1990 - 1991 Corvette: Service Bulletin: 3-2 Coast Down Clunk

Subject: 3-2 COAST DOWN CLUNK (INSTALL SERVO SPRING)

Model and Year: 1990-91 CORVETTE WITH 4L60 AUTOMATIC
TRANSMISSION

Bulletin Number: 91-372-7A - (06/27/1991)

Figure 1

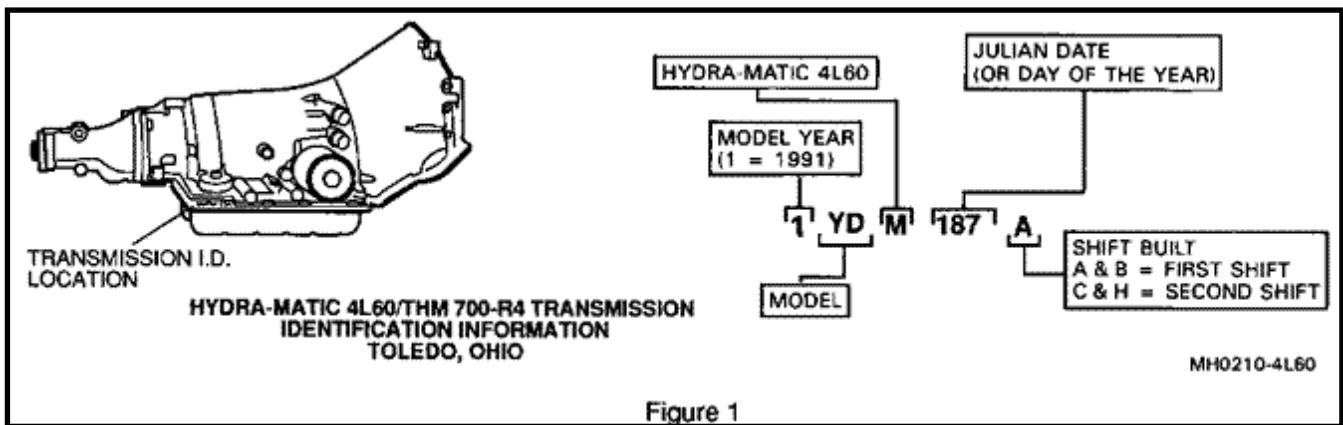
Date of Production Change: (Figure 1)

Beginning May 20, 1991 (Julian Date 140), all 1 YHM models of the HYDRA-MATIC 4L60 were built using the new servo cushion assist spring and spacer plate.

Refer to Figure 2

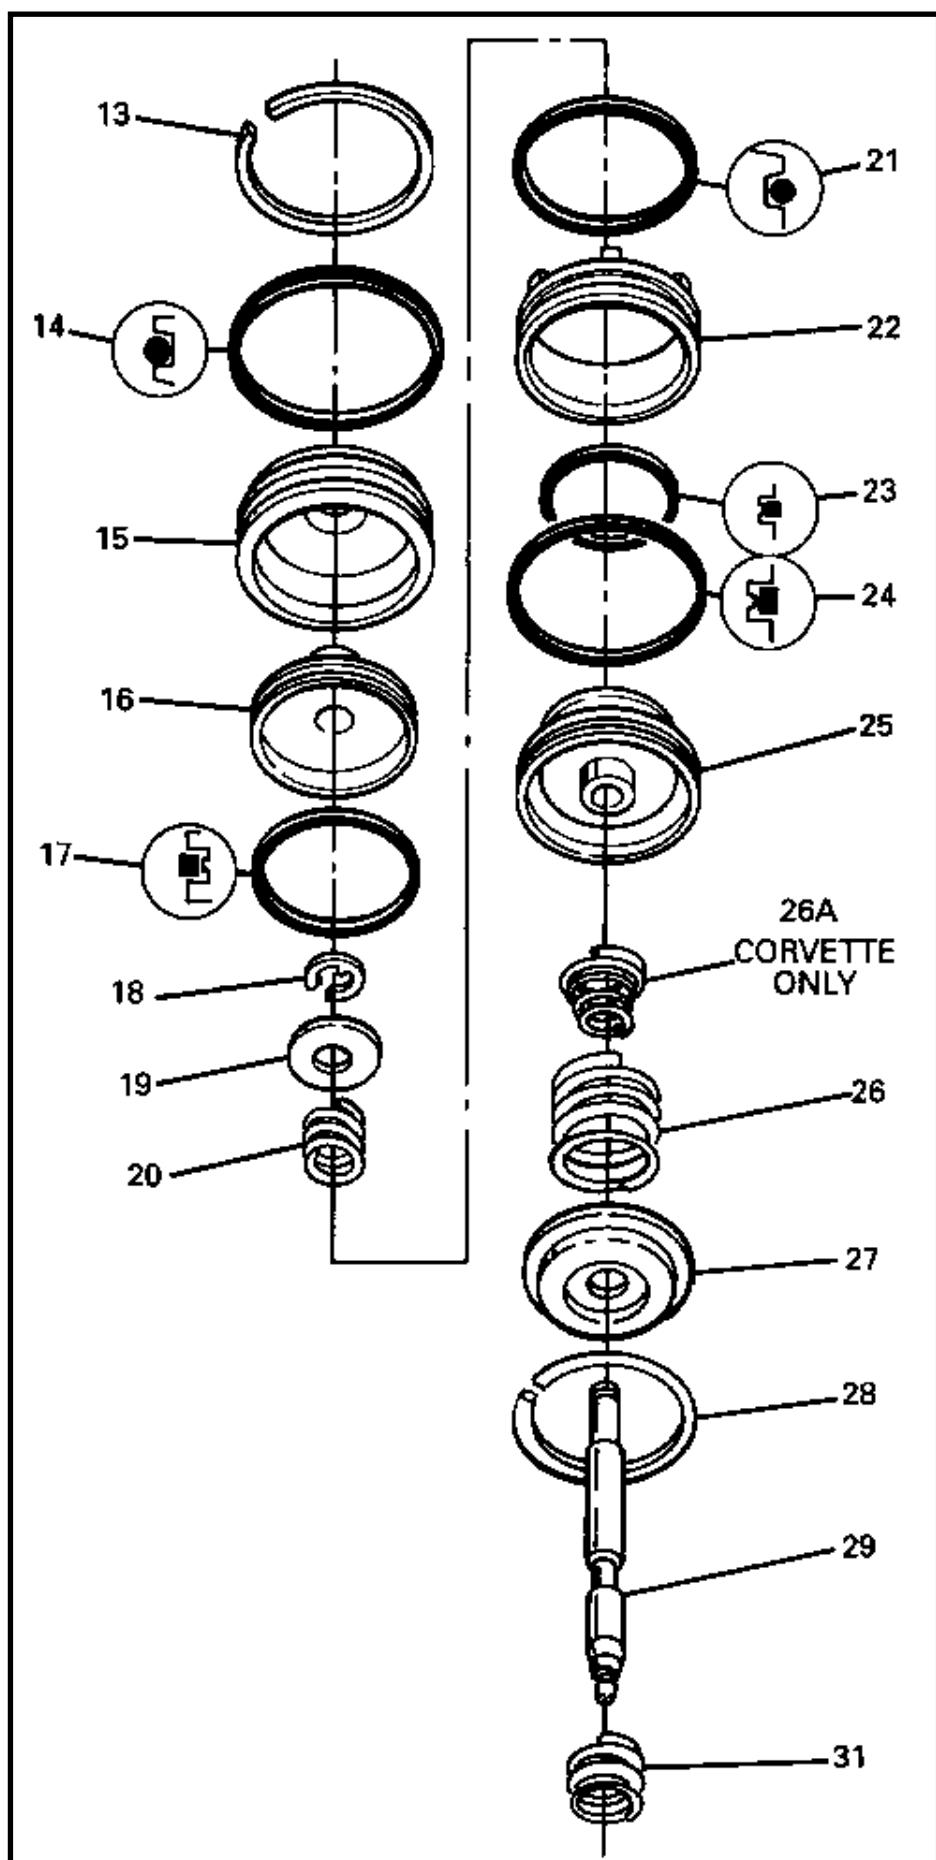
A new 2-4 servo cushion assist spring and spacer plate have been released to alleviate this condition. The new spring is a conical spring which nests inside the current 2-4 servo cushion spring. The new spacer plate has a modified third clutch exhaust orifice.

Service Information: (Figure 2)

Install the new servo cushion assist spring inside the current servo cushion spring as shown in figure 2. Figure 2 shows the ONLY way the spring should be installed. Do not install the spring upside down. The new spring should not be used by itself.

Refer to the Automatic Transmission Unit Repair Section of the appropriate service manual for spacer plate removal and installation information. The 2-4 servo cushion assist spring is not shown in a service manual. Follow instructions for installing a 2-4 servo cushion spring, and add the servo cushion assist spring as shown in figure 2 of this bulletin.
